## RESOLUTION NO. 2008-051

### ADOPTING FINDINGS OF FACT AND APPROVING THE LEISURE VISTAS TENTATIVE MAP LOCATED AT 5423 RIO LINDA BOULEVARD, SACRAMENTO, CALIFORNIA. (P99-094) (APN: 226-0061-020, 028)

# Exhibit A – Tentative Map

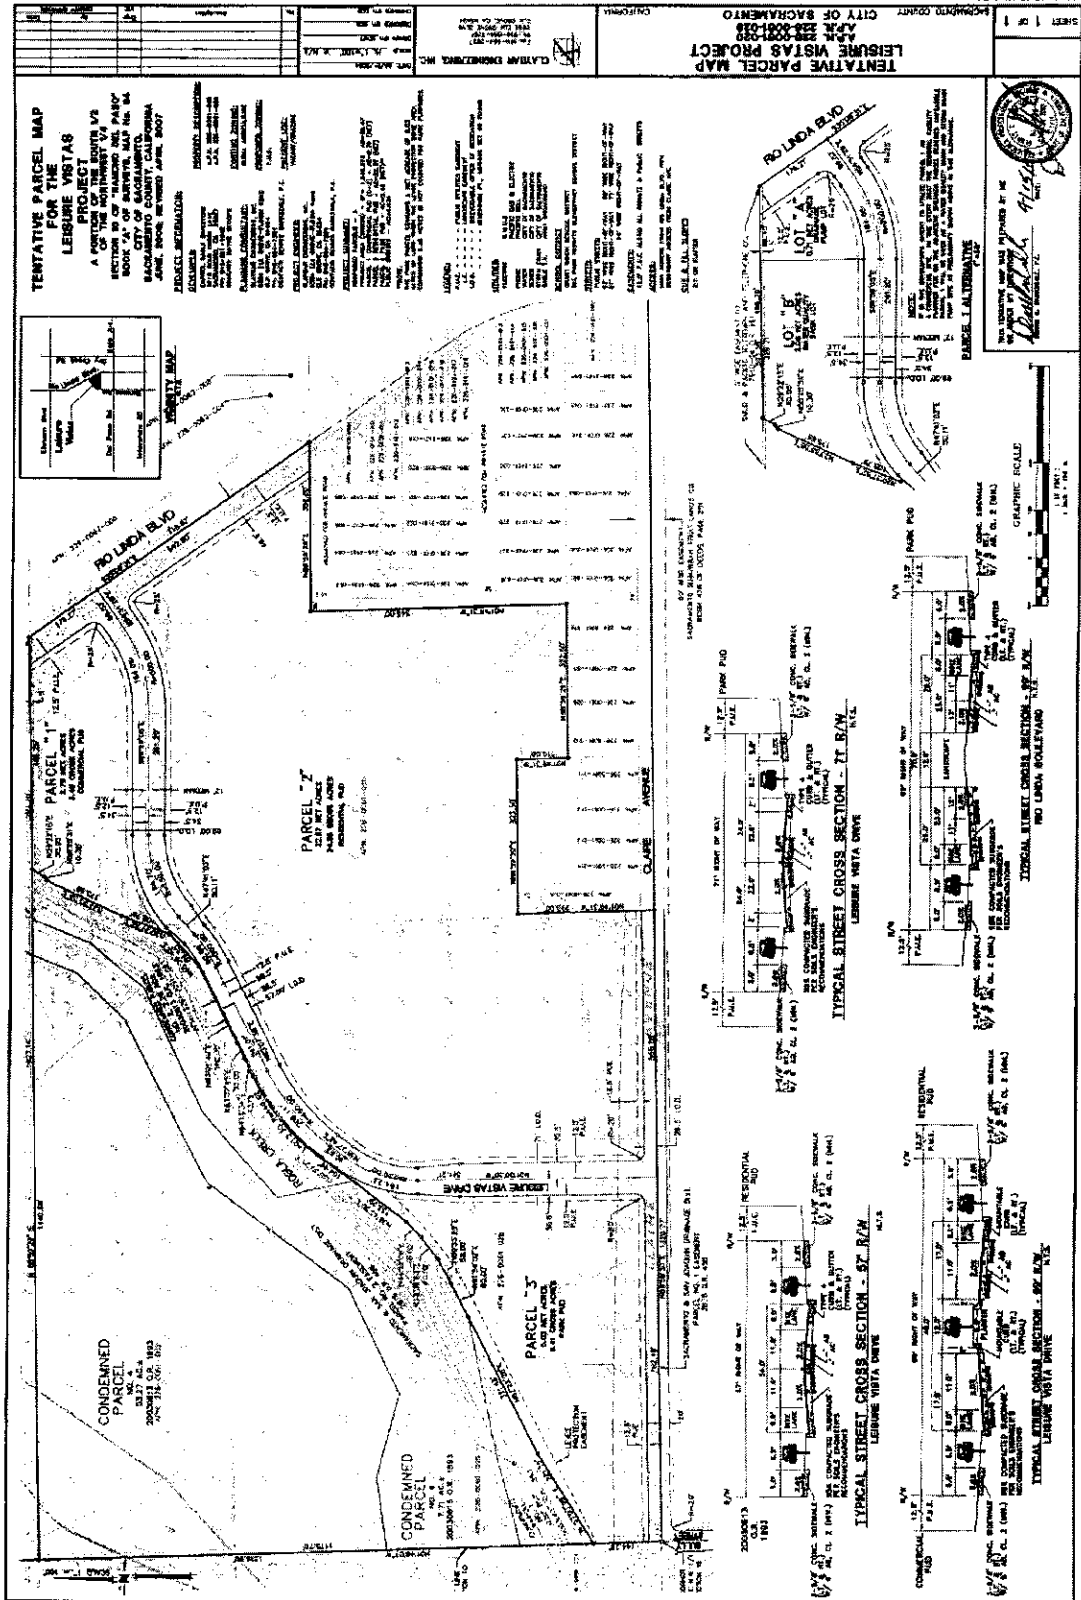
**NOTE:** These conditions shall supersede any contradictory information shown on the Tentative Map approved for this project (P99-094). The design of any improvement not covered by these conditions shall be to City standard.

4. Construct Claire Avenue as follows: 60' of right-of-way currently exists for Claire Avenue and Claire will be constructed as a City Standard 59' (half street only) right-of-way adjacent to this site the extra .5 feet shall be added to the planter strip. The map shows a curve in the Claire Avenue right-of-way as it approaches Sully Street which will not be allowed unless a compelling reason for the deviation is provided.

40. Dedicate in fee title, at no cost to the City, Lot A, for a regional drainage pump station. The Tentative Map shall reflect the location and alternate location of said dedication.

41. Dedicate in fee title, at no cost to the City, Lot B, etc. for a flood control and/or storm water quality detention basin. The Tentative Map shall reflect the location and alternate location of said dedications.
